Reversed Capacitor on RVON Cards Causes Communication Errors

RTS™ TECHNICAL BULLETIN

a) RVON 1 & RVON-I/O

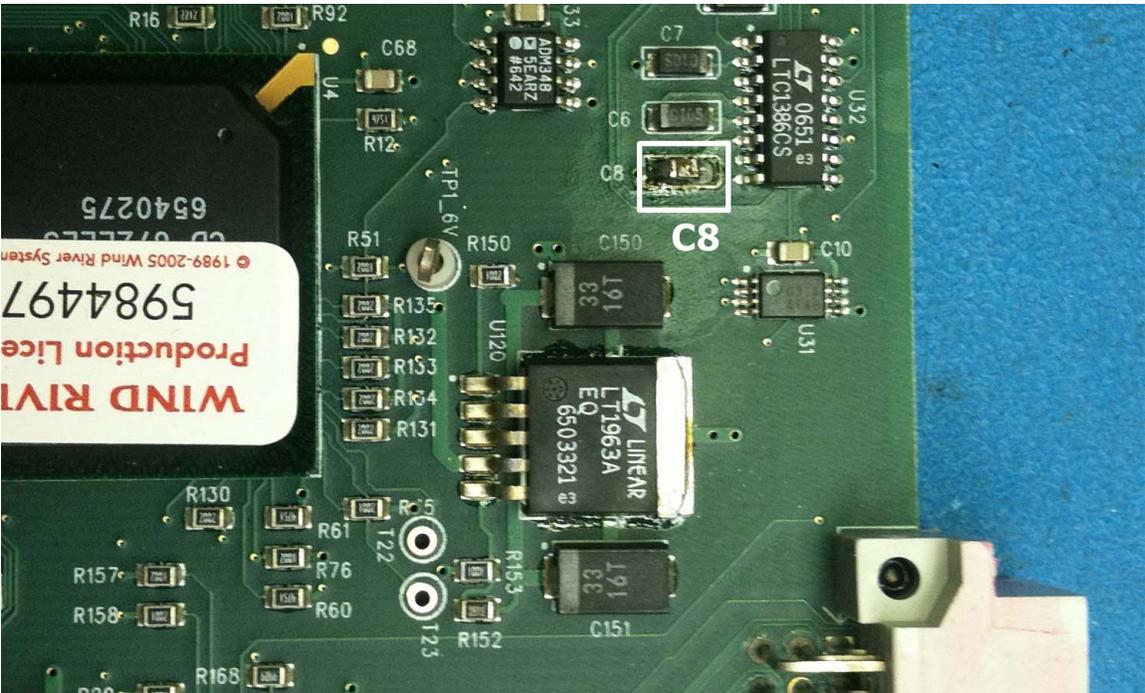
Part 1: Applies to all RVON cards

Old part number: 102877012

New part number: 102881882, NIC, NMC1206X7R105K50TRP

In case the particular NIC cap is not available, a similar cap can be used, i.e. 1206, 1uF, X7R or X5R, the minimum voltage requirement is 16V.

Part 2: Applies to ADAM RVON-16 Card ONLY

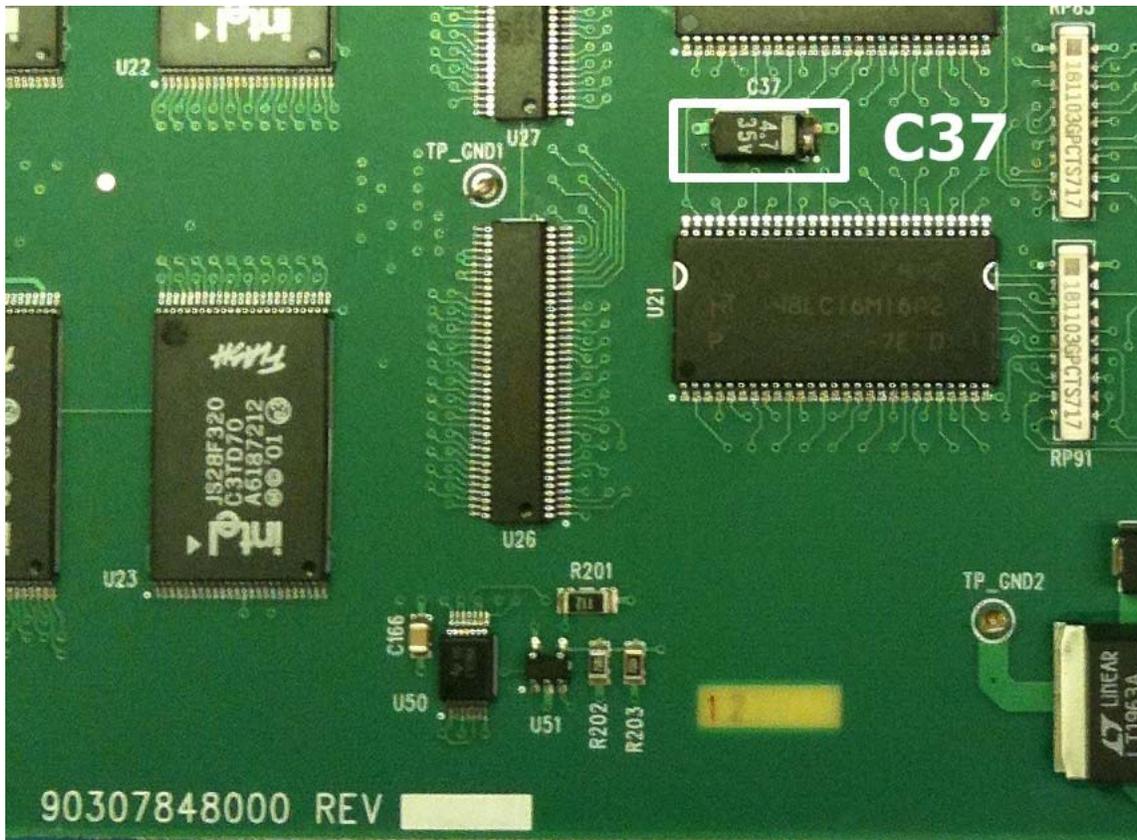
C37 was soldered upside down on RVON-16: 90307848000. It should be replaced with a new capacitor per the silk screen orientation indication dot.

Supplier Part number: 102877027, NIC, NTC-T475K25TRCF or NTC-T475M25TRCF

In the event that the particular NIC cap is not available, a similar cap can be used, i.e. 2412, 4.7uF, tantalum or ceramic, the minimum voltage requirement is 16V.

DO NOT reverse the old cap and solder it back for either modification. **ALWAYS** use a new capacitor.
